Environmental Permit Variation (UP39093SG)

July 2024- RFI

Cliniwaste Health South Limited
Crossgate Drive Clinical Waste Treatment Facility
Unit A, Crossgate Drive
Queens Drive Industrial Estate
Nottingham
NG2 1LW

Figure 1: Process Map for Proposed Variation

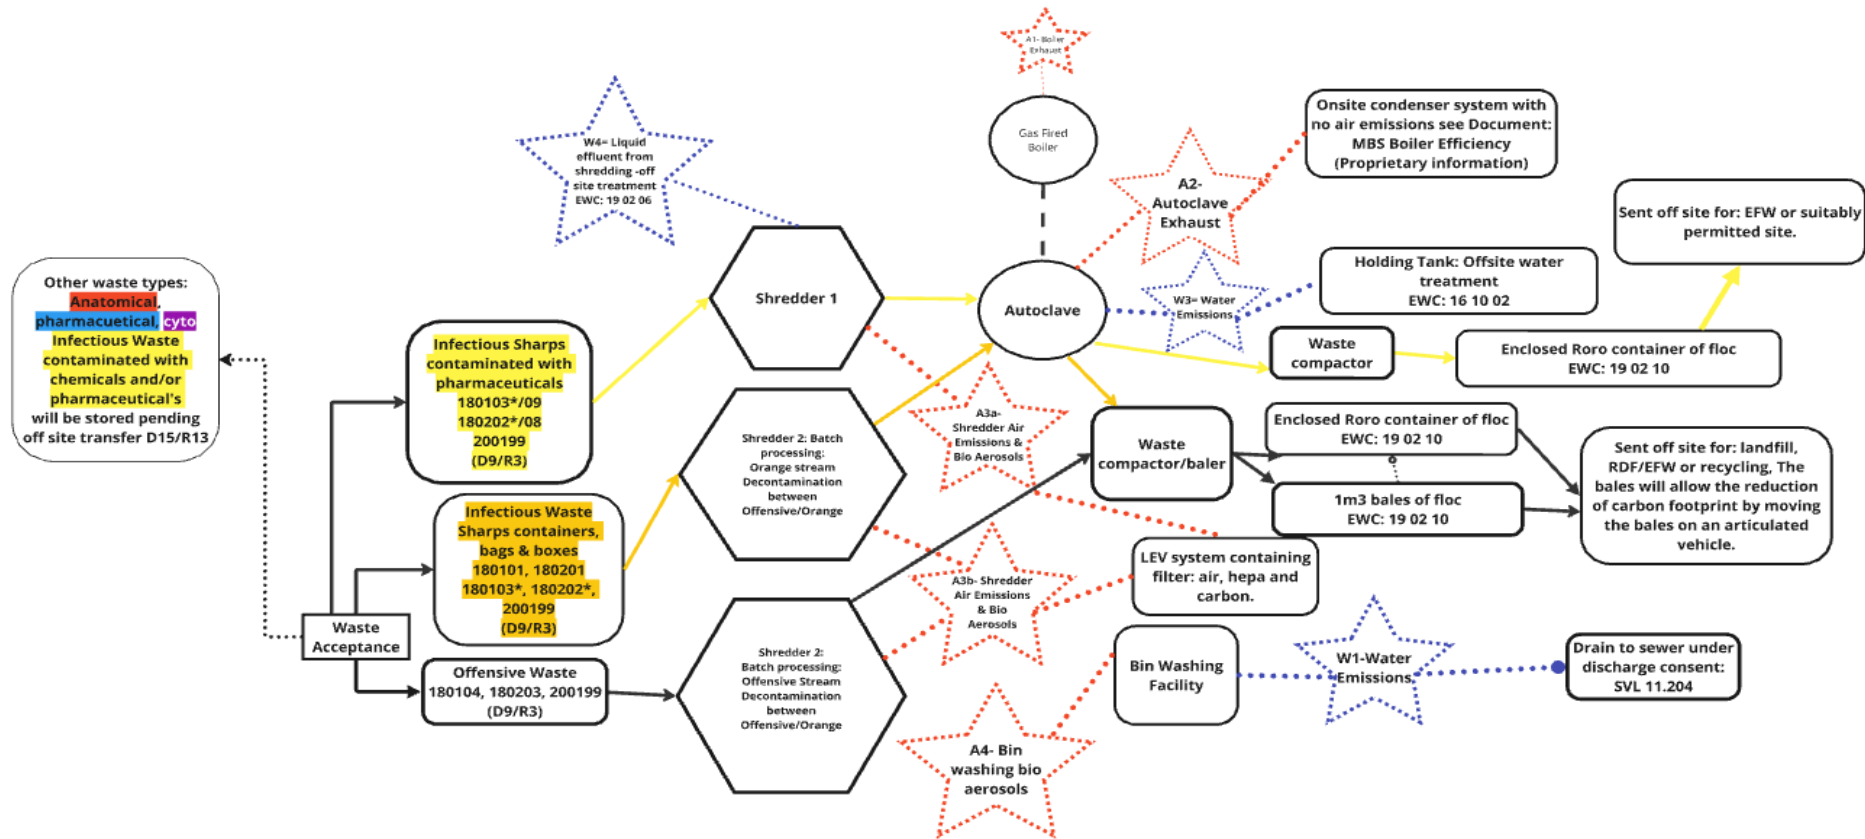
Q: In reference to process flow diagram “Cliniwaste Project Yellow: Process Map”, (PowerPoint). Please include a finalised process flow diagram (PFD), identifying the changes proposed in this variation phase only which includes the processes and activities impacted by additional waste streams. (Likely to be included as part of the addendum: Section 2?)

A: An updated PFD has been included in the addendum, a copy of which is below.
